SUBJECT: DRAFT SER FOR THE PROPOSED OPERATION OF MCGUIRE UNITS
1 AND 2 WITHOUT UPPER HEAD INJECTION

SAFETY EVALUATION OF THE PROPOSED OPERATION OF MCGUIRE UNITS 1 & 2 WITHOUT UPPER HEAD INJECTION

Figure / Licensing Model Calculations

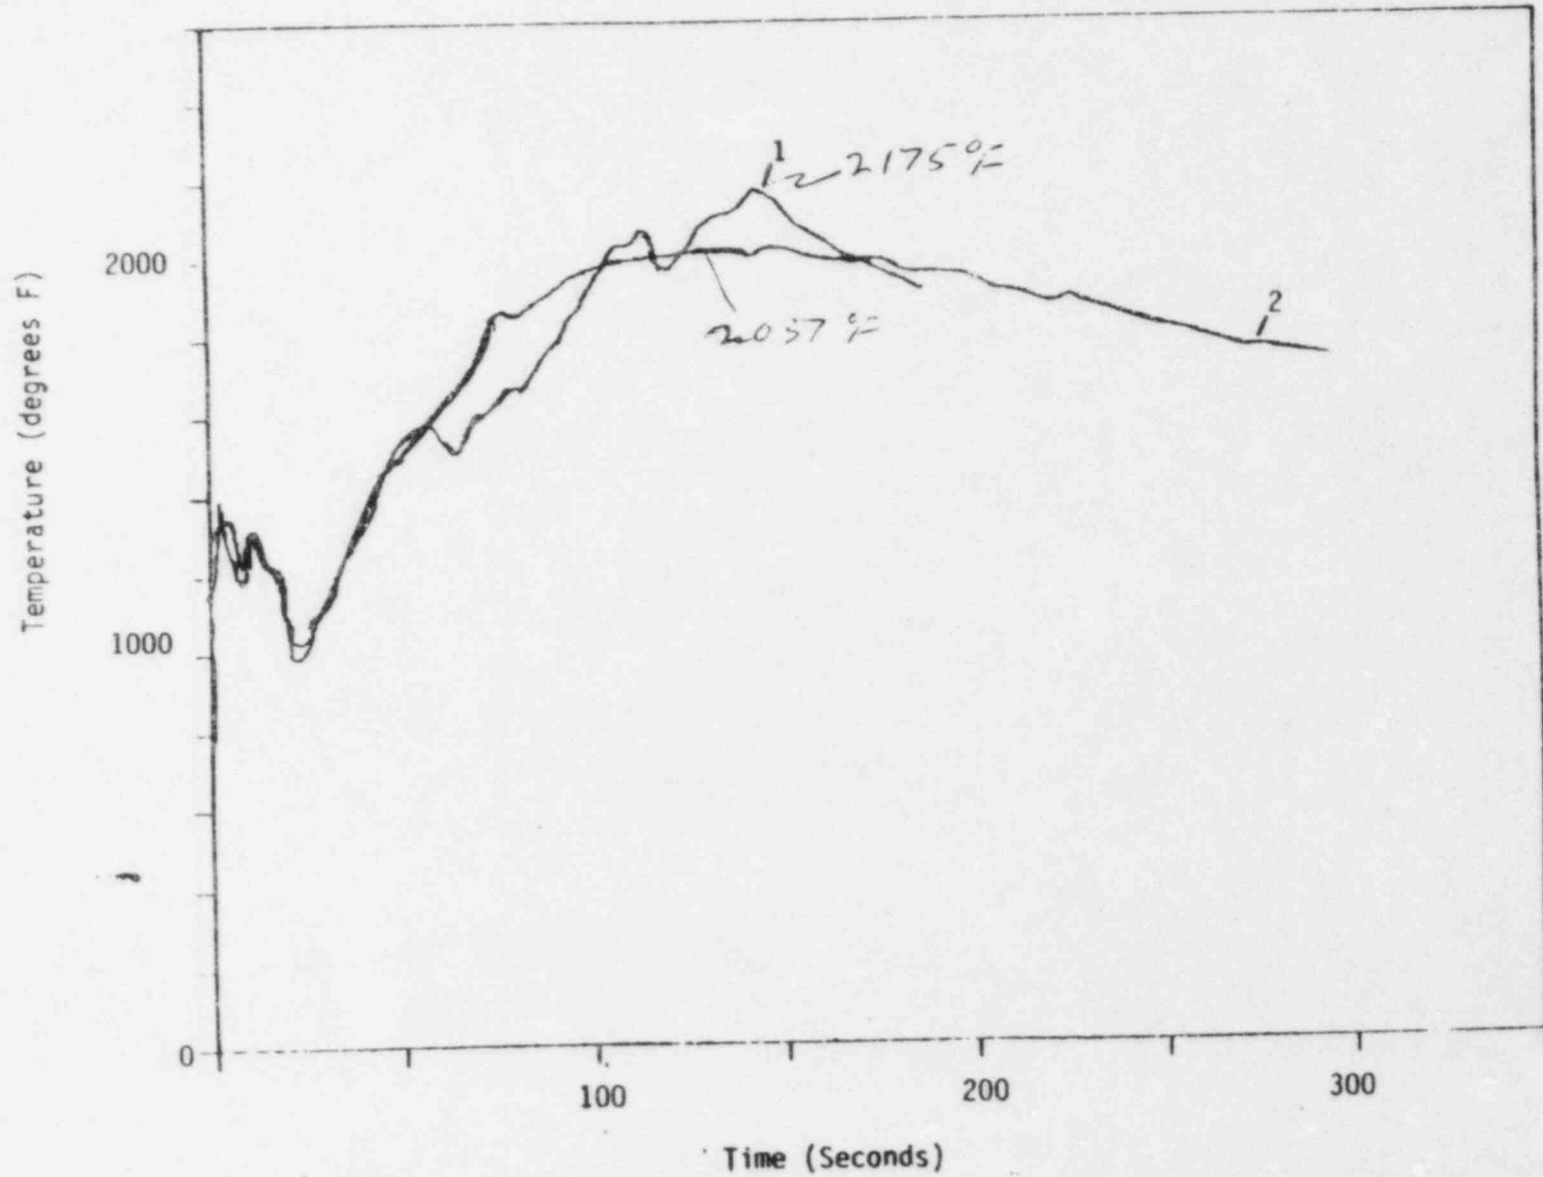
Figure 1 compares evaluation model calculations. The plant transient shown as case 2 has been superseded by an analysis submitted on March 17, 1986 as a safety analysis revision. Unfortunately, the revised figure was not presently available. The peak clad temperatures for Case 2 and the revised Case 2 during blowdown are essentially identical because they occur before UHI system injection. The hot rod is somewhat cooler at the end of blowdown with UHI. UHI delays reflood and the hot rod reaches a higher temperature.

Figure 2

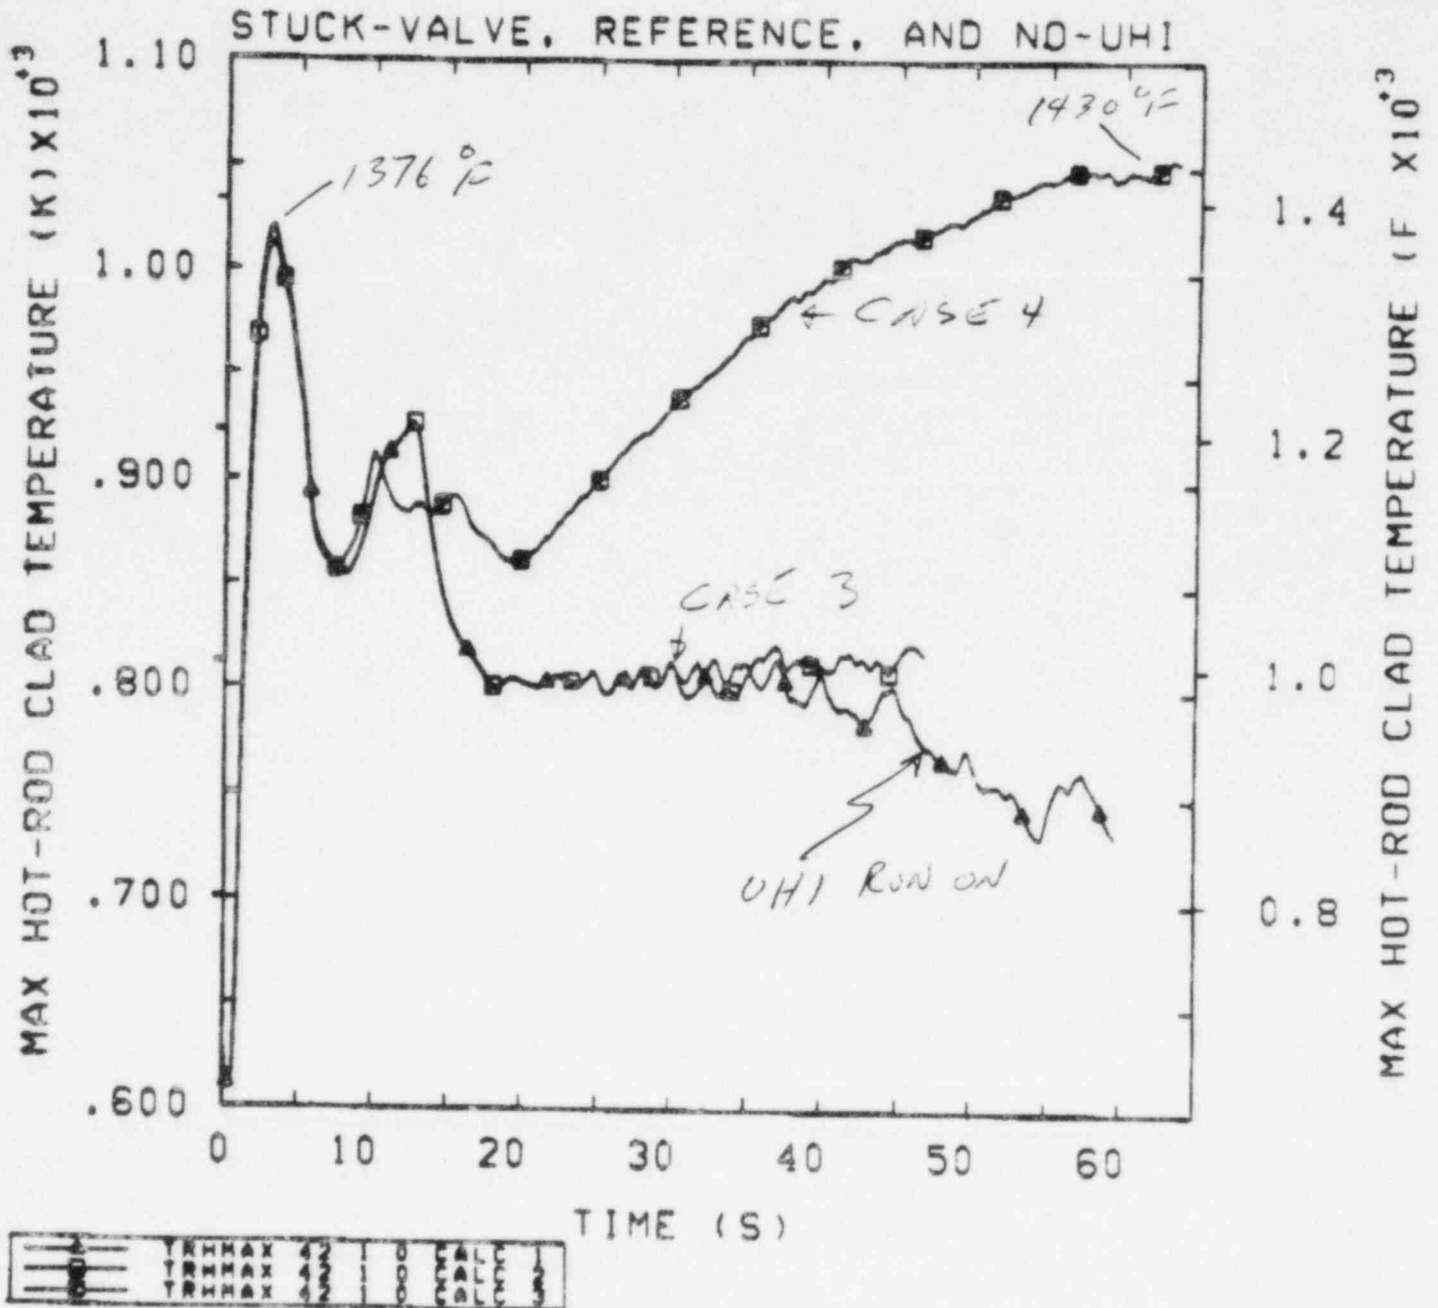
The best estimate calculations shown in Figure 2 produce about the same PCT during blowdown as with the evaluation model. The UHI case remains quenched, while the non-UHI case shows a reheat to 1430°F (some 600°F cooler than the EM results).
